RE: **DOCKET NO. 474** - The Connecticut Light & Power Company d/b/a Eversource Energy application for a Certificate of Environmental Compatibility and Public Need for the Greater Hartford-Central Connecticut Reliability Project that traverses the municipalities of Hartford, West Hartford, and Newington, which consists of (a) construction, maintenance and operation of a new 115-kilovolt (kV) electric transmission line within existing Eversource, Amtrak and public road rights-of-way and associated facilities extending overhead approximately 2.4 miles and underground approximately 1.3 miles between Eversource's existing Newington Substation in the Town of Newington and existing Southwest Hartford Substation in the City of Hartford; (b) modifications to a .01 mile section within existing Eversource right-of-way of the existing overhead 115-kV electric transmission line connection to the Newington Substation (Newington Tap); and (c) related modifications to Newington Substation and Southwest Hartford Substation.

Subject: Docket 474 (Eversource)
115-Kilovolt Electric Transmission Facility
Towns of Hartford, Newington and West Hartford

Thank you for your letter dated July 21, 2017, req

REV #	INTERSECTION #	155-264

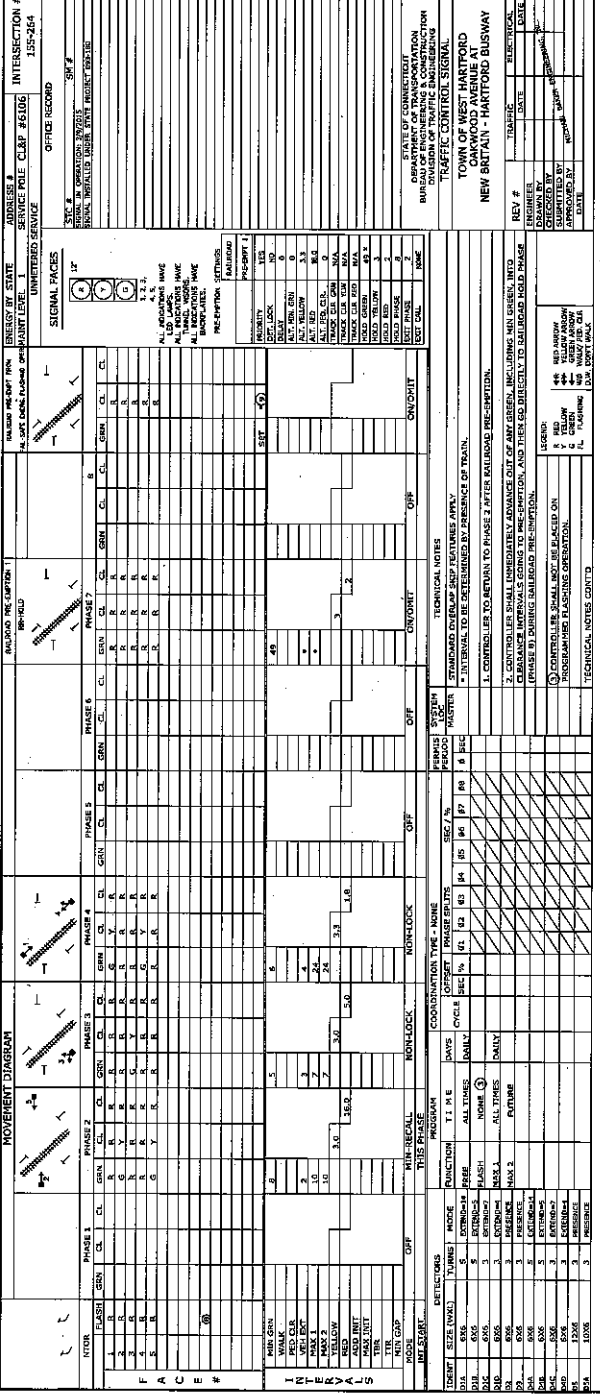
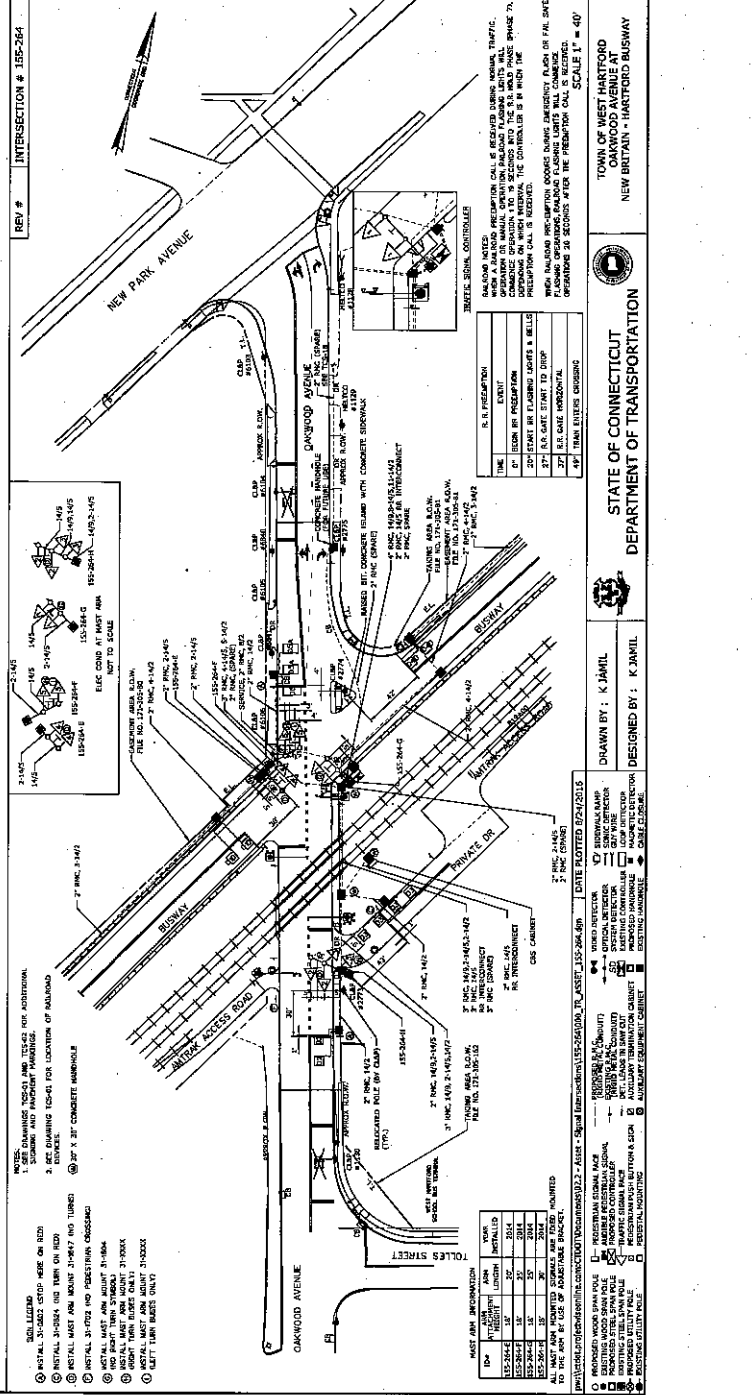
9. There is an existing at-grade railroad crossing with railroad gate devices at Oakwood Avenue No. 1 in West Hartford. Eversource should ensure the proposed structure (STR No. 40) and overhead crossing will not conflict with the existing railroad devices. The traffic signal plan (Intersection No. 155-264) for this at-grade railroad crossing is enclosed.
